Consists of requested additional info. concerning the inservice inspection program and pump & valve test program for Turkey Point Unit No. 4.....

Re: Turkey Point Unit 4
Docket No. 50-251
Pump & Valve Program and
Inservice Inspection Program

Re: Turkey Point Units 3 & 4
Docket Nos. 50-250 & 50-251
Pump & Valve Program and
Inservice Inspection Program

FIGURE A-22

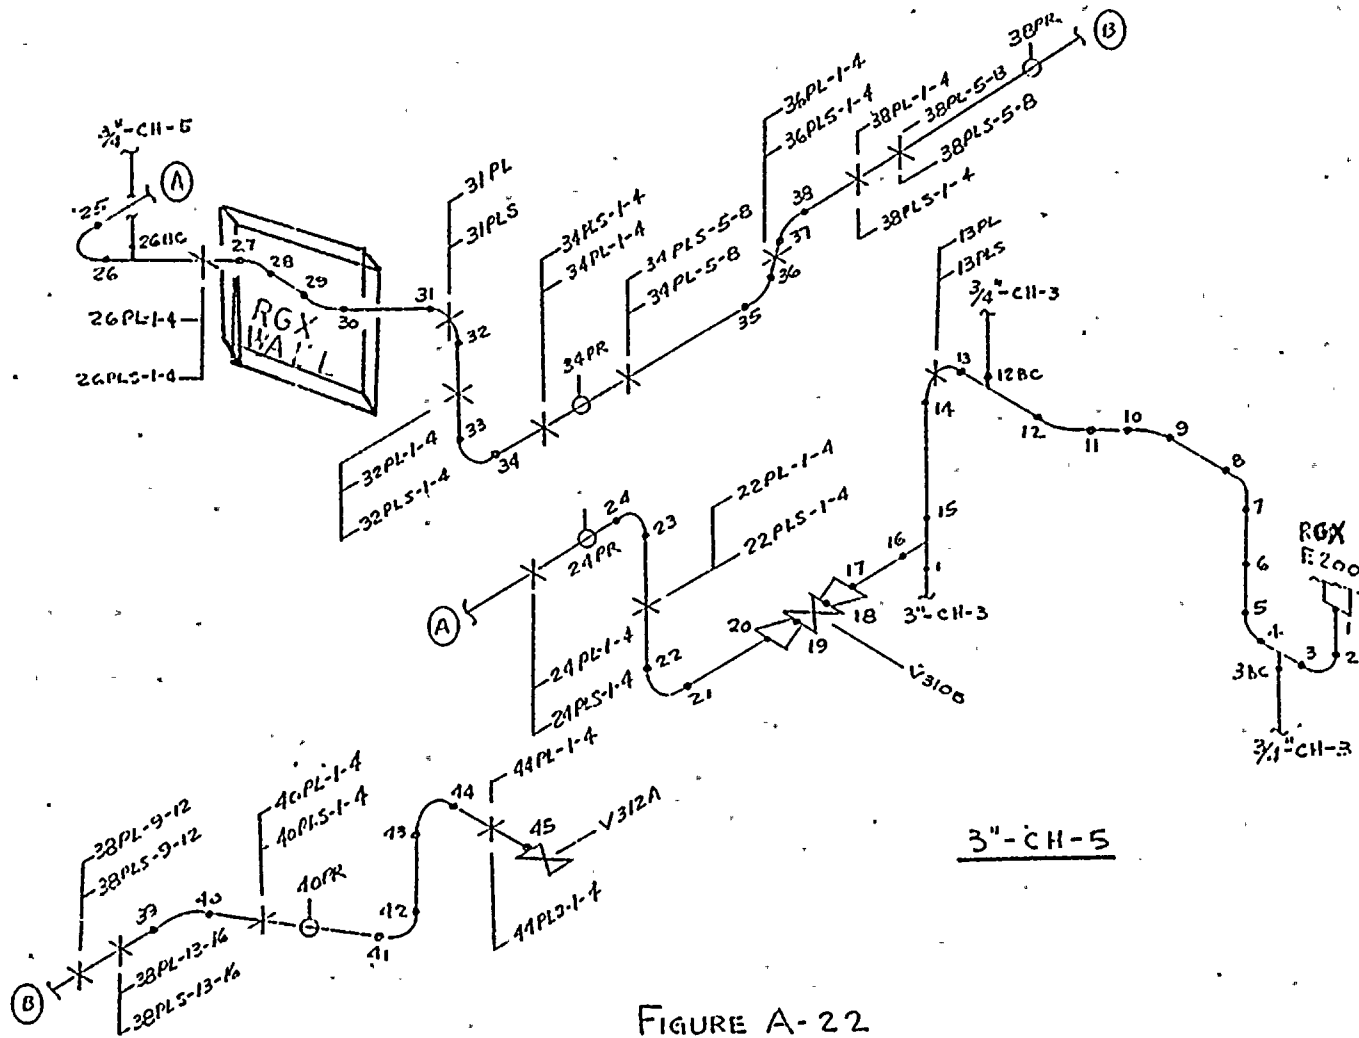
On the Chemical and Volume Control System examination in loops 3"-CH-3, 3"-CH-5, and 2"-CH-7 provide data (figures or drawings) to support the statement that certain B-J welds within these loops cannot be examined due to inaccessibility. The welds in the order of loops listed above are 20, 21, 22; 27, 28, 29, 30; and 6, 7, 8.

These welds are embedded in concrete and, therefore, they cannot be examined by any nondestructive testing (NDT) method. (See attached Figures A-22, A-23, and A-36.)
